SUNDRY NOTICES AND REPORTS ON WELLS

PLUG AND ABANDONMENT PROCEDURE

Jicarilla D #1

CONDITION OF APPROVAL FOR PLUGGING AND ABANDONMENT

Proposed P&A

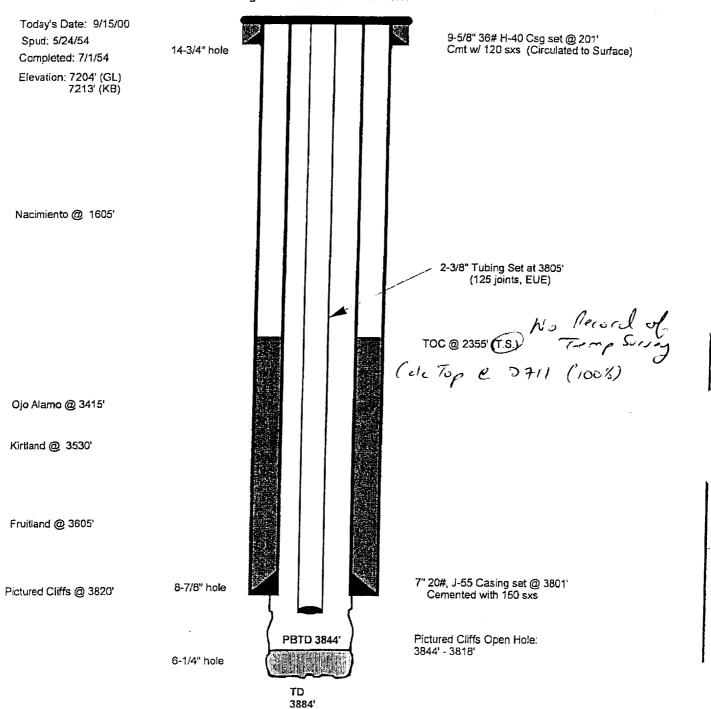
Submittal of log section of temperature survey is required for the following wells in order to verify cement top indicated on production string. Our records do not reflect that temperature surveys were ran on these wells so verification is required.

- Jicarilla D 4
 API No. 30-039-06301
 1950' FSL & 990' FEL
 Section 30, T. 26 N., R. 3 W.
- Jicarilla D 6
 API No. 30-039-06238
 990' FNL & 1650' FWL
 Section 31, T. 26 N., R. 3 W.
- 3. Jicarilla D 1 API No. 30-039-06236 1190' FNL & 990' FWL Section 32, T. 26 N., R. 3 W.
